ITS3 activities in Bari

BBM6 Thermal Test Assembly

Super-ALPIDE mandrel

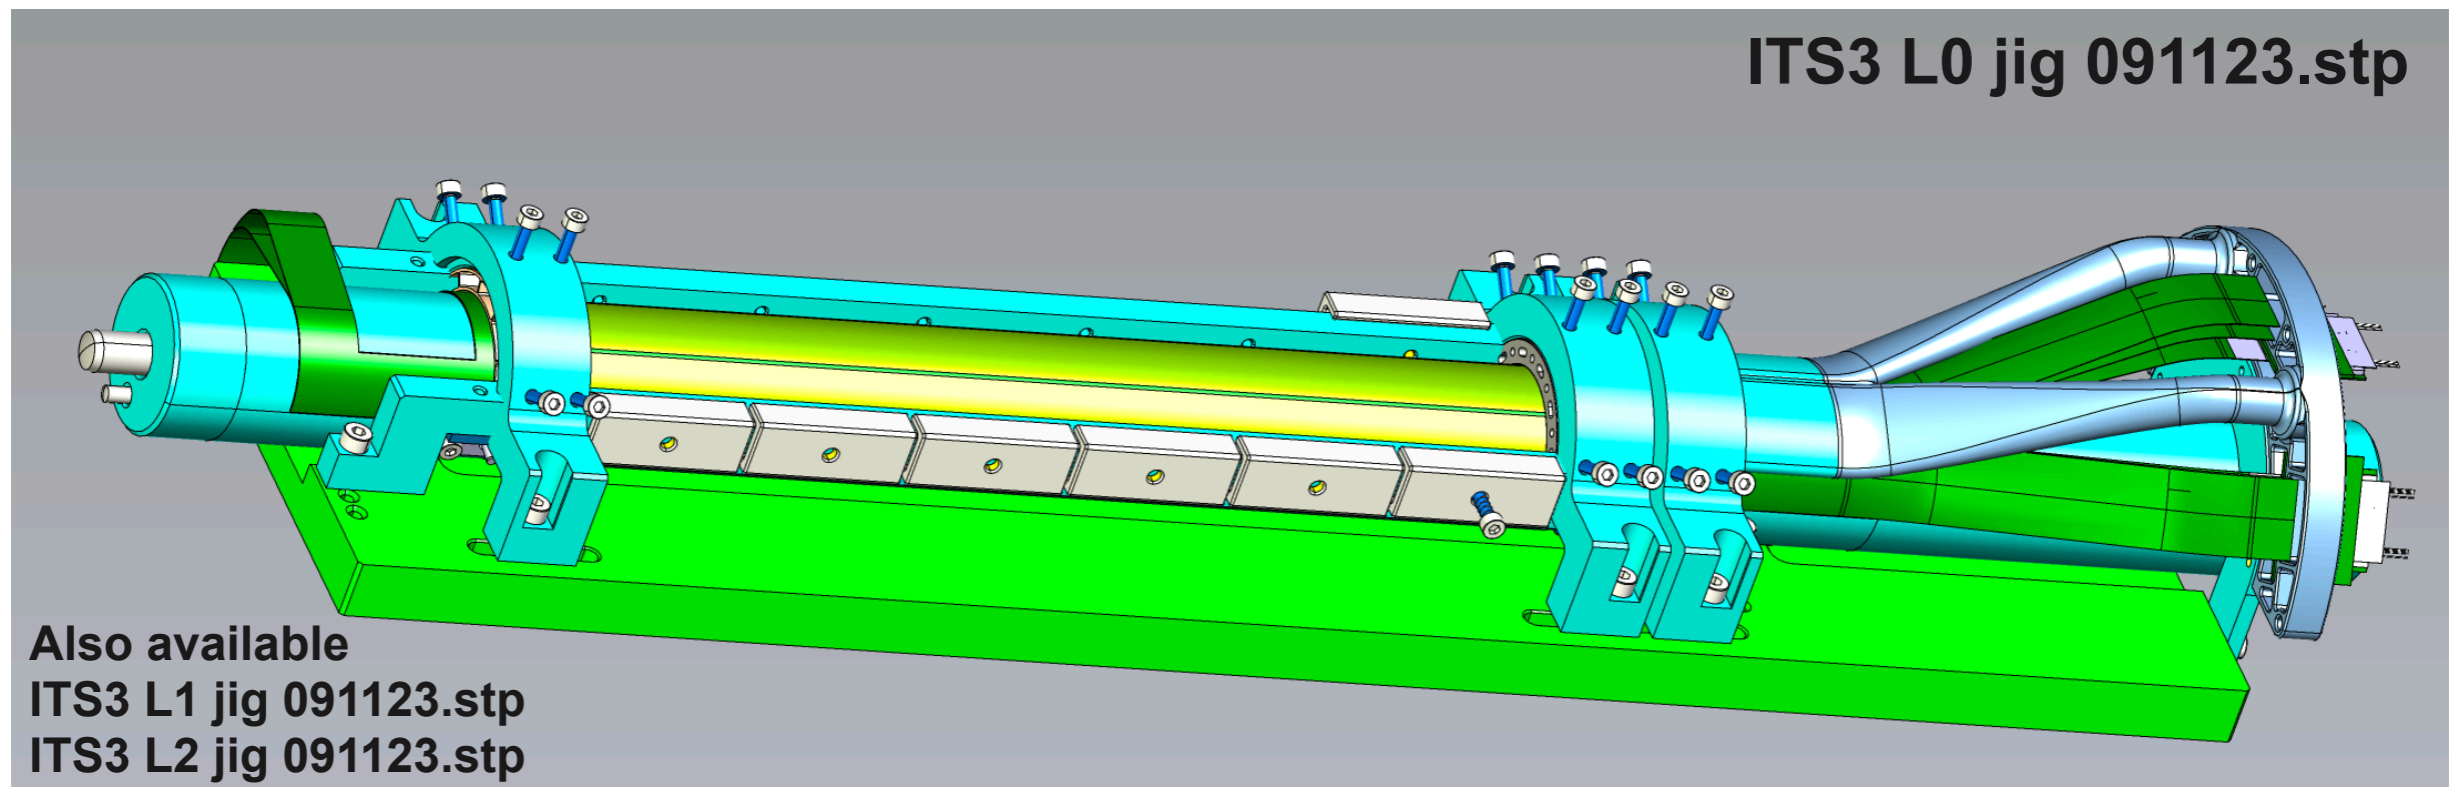
Last shared version from 09/11/2023.
Is this still valid? Can this be used for production?

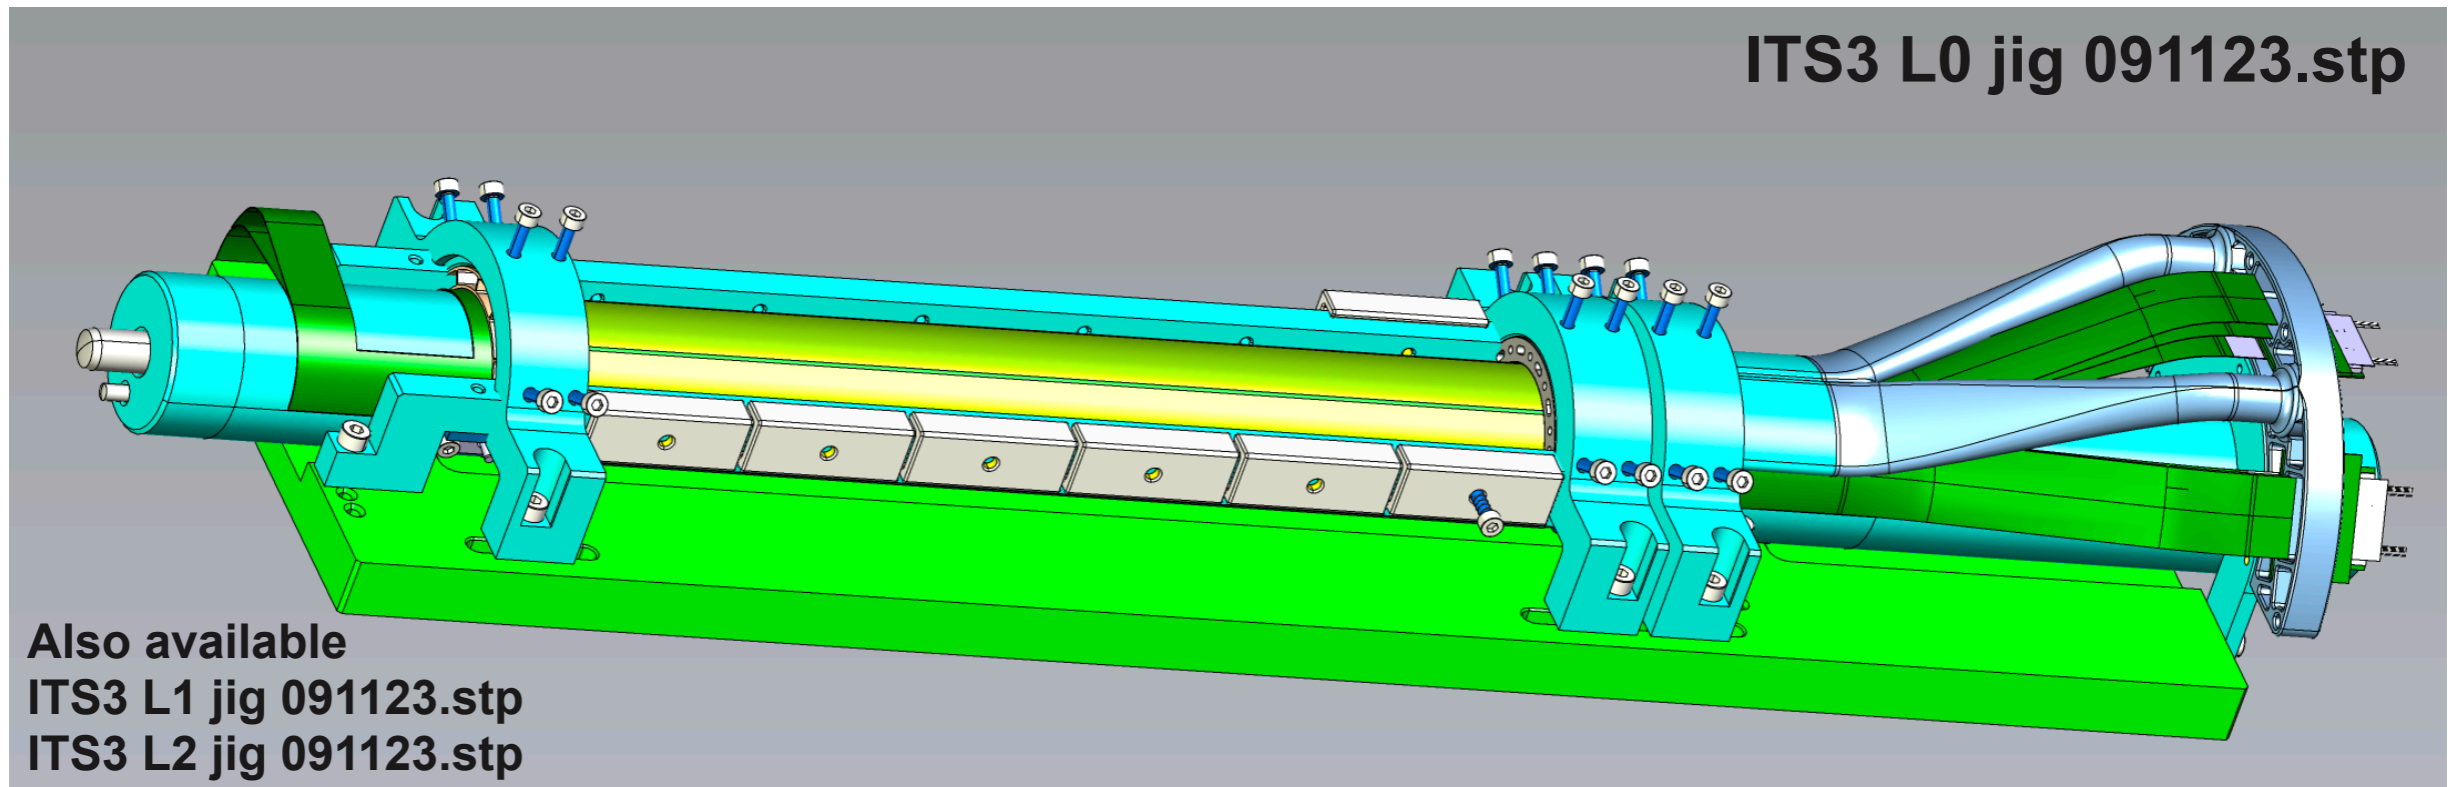
Is this still valid? Can this be used for production?

Does this apply also to the gluing tools?

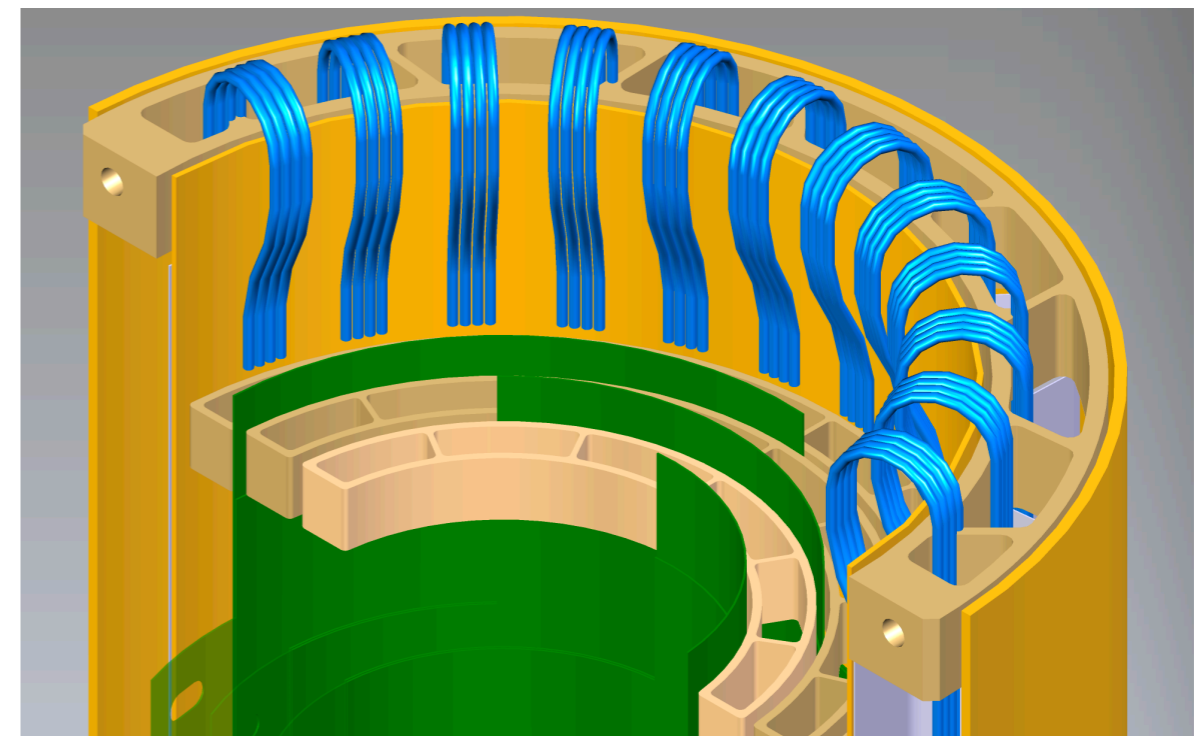
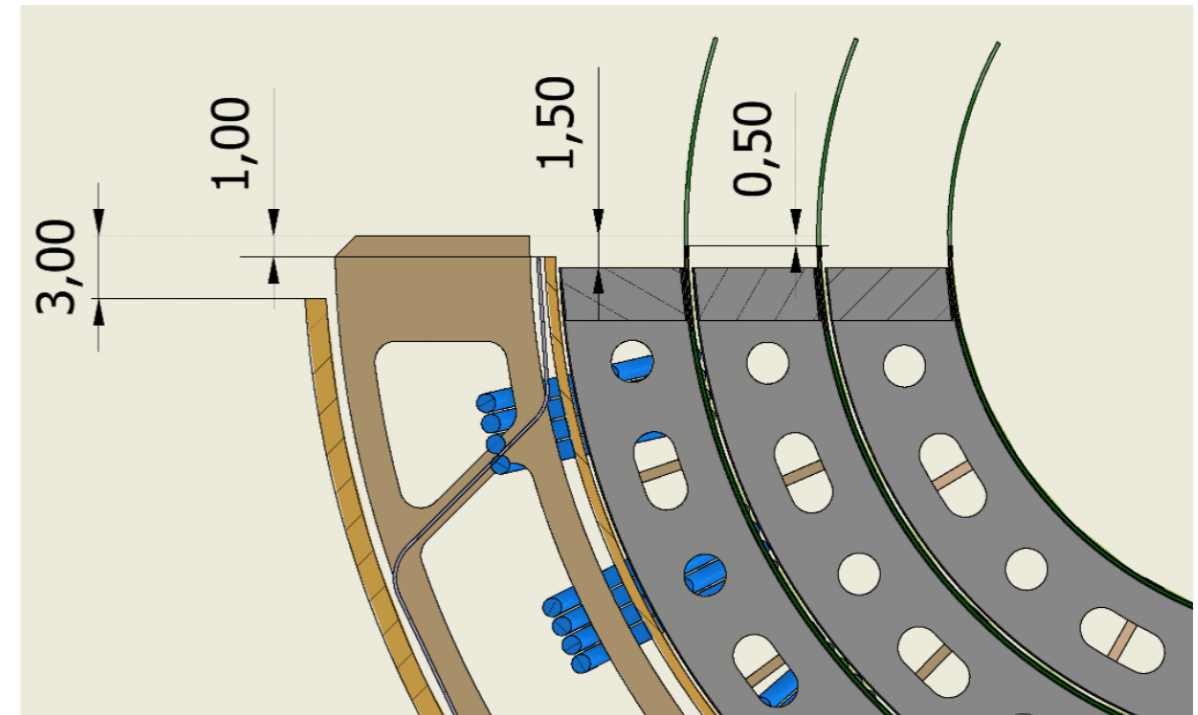
{Gael}: “We have a gap of 1mm between the cyss and Plexiglas since we will have 2mm between top and bottom detector (1mm between sensors and 2mm between cyss if you look in the step) Massimo and Aitor did some airflow tests with that gap open and close” → **Request needs clarifications**

{Gael}: “And the 4 pins holes in the cyss for the gluing jig (same position as the cyss in the step)” → **Request needs more details**

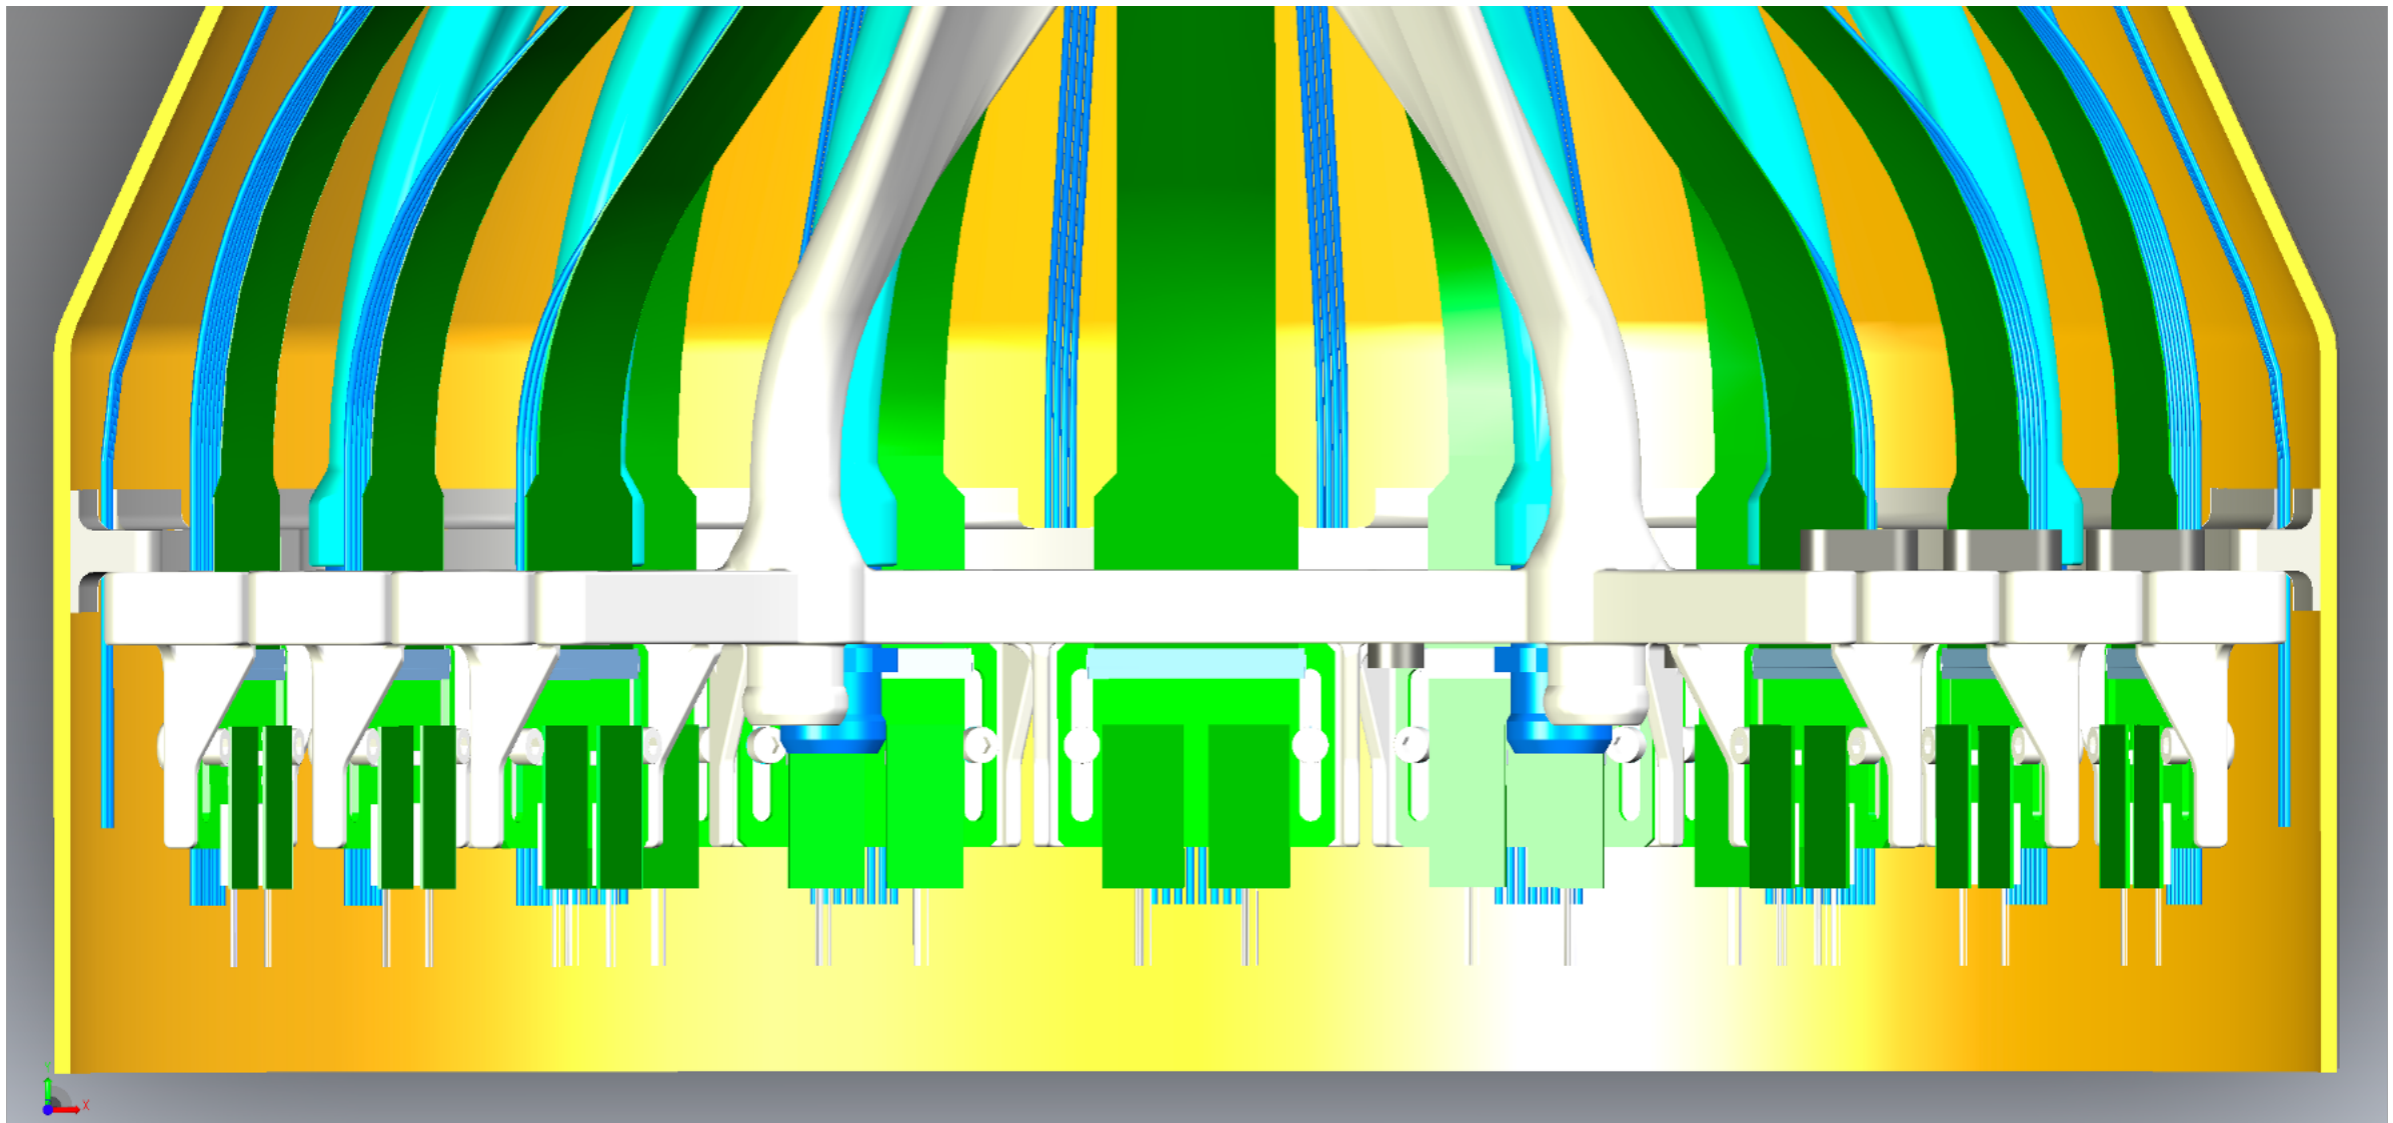
{Gael}: “Can you change the outside diameter of the cone to 290 or 300mm and add some holes to have the possibility to fix an extension like the service barrel in some future tests ?” → **Yes, if needed, but needs more informations**

ITS3_BBM4_12022024

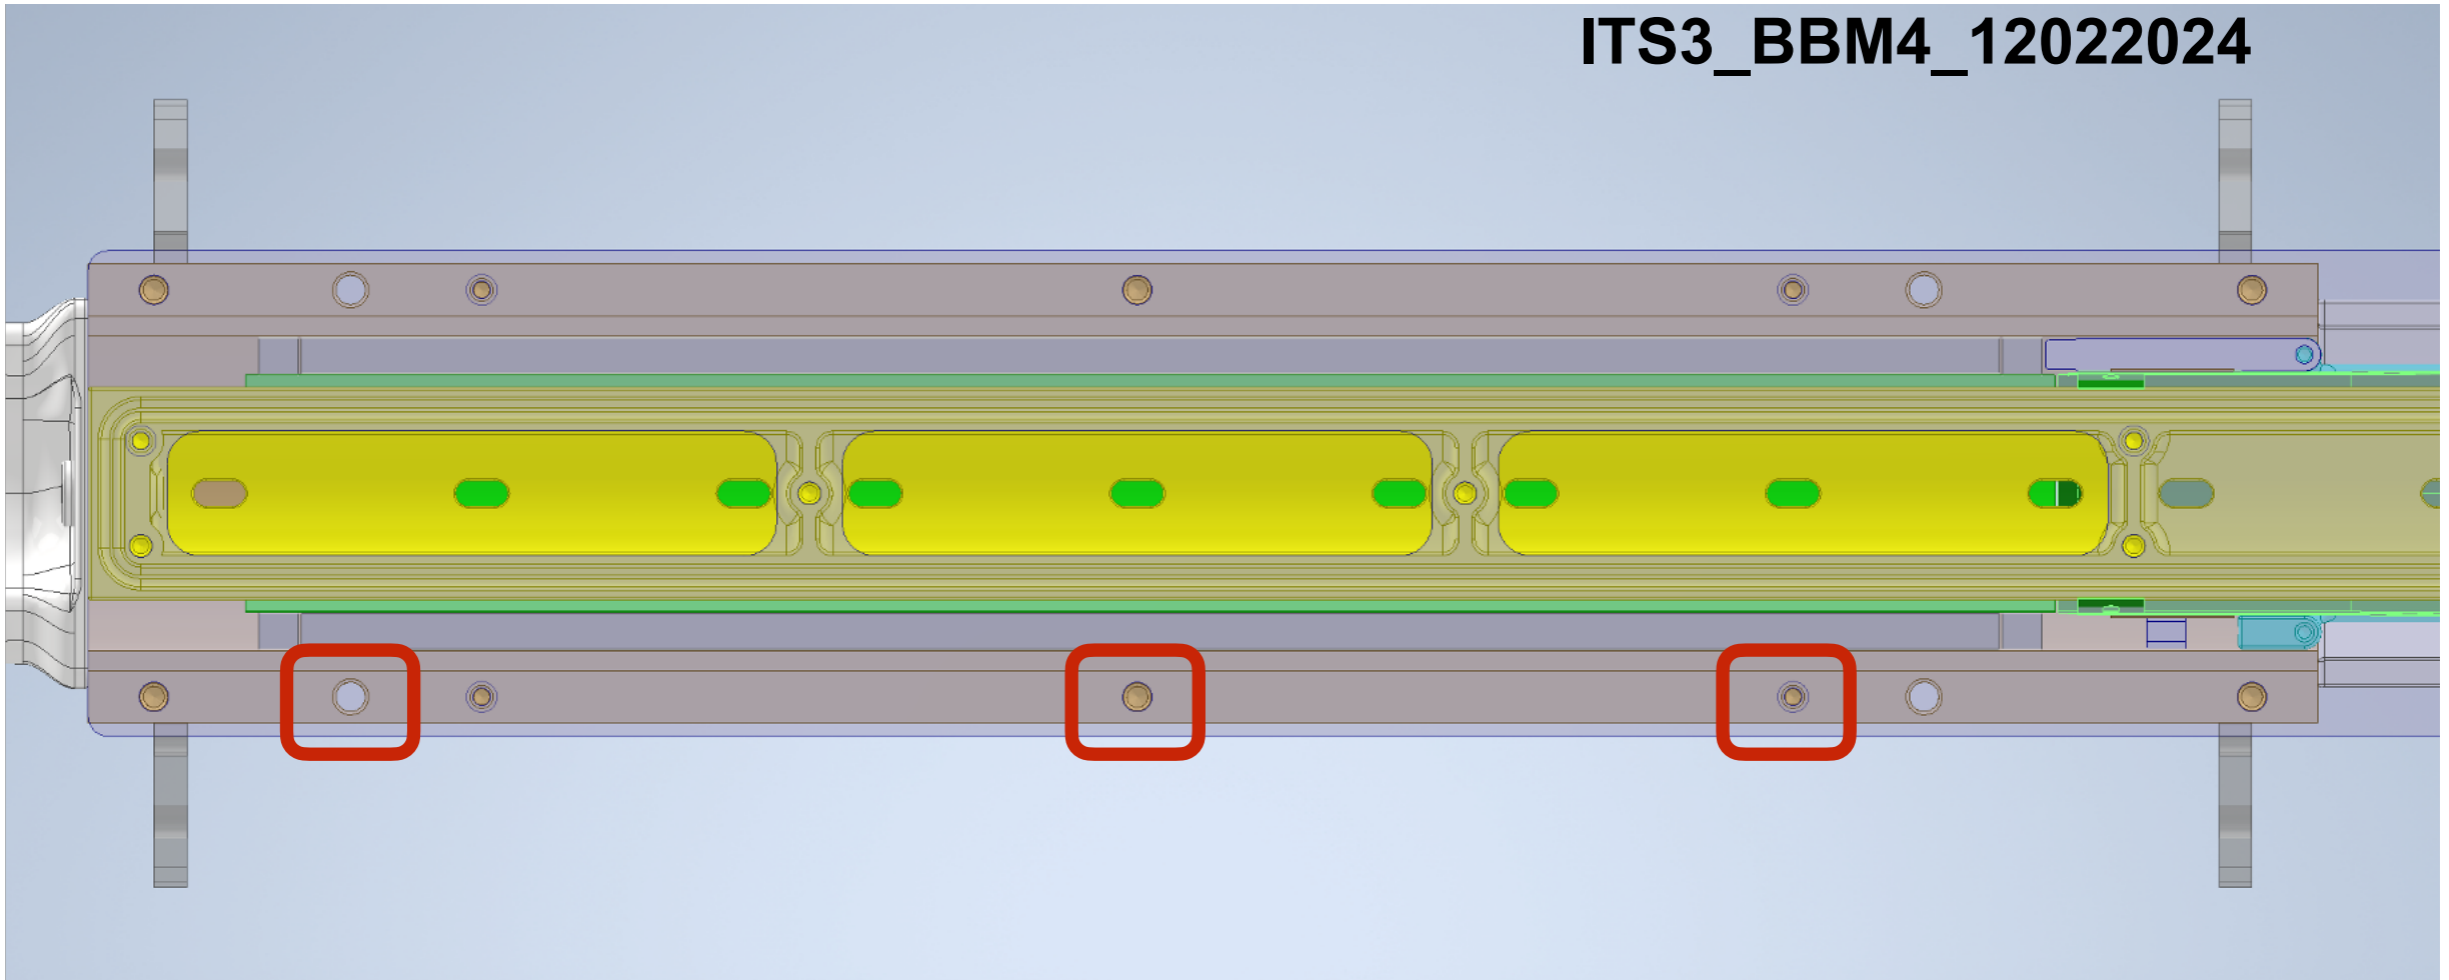
Holes in the CYSS without corresponding opening in the covering plexiglass.
Not implemented at the moment.
Should be included? At which position?
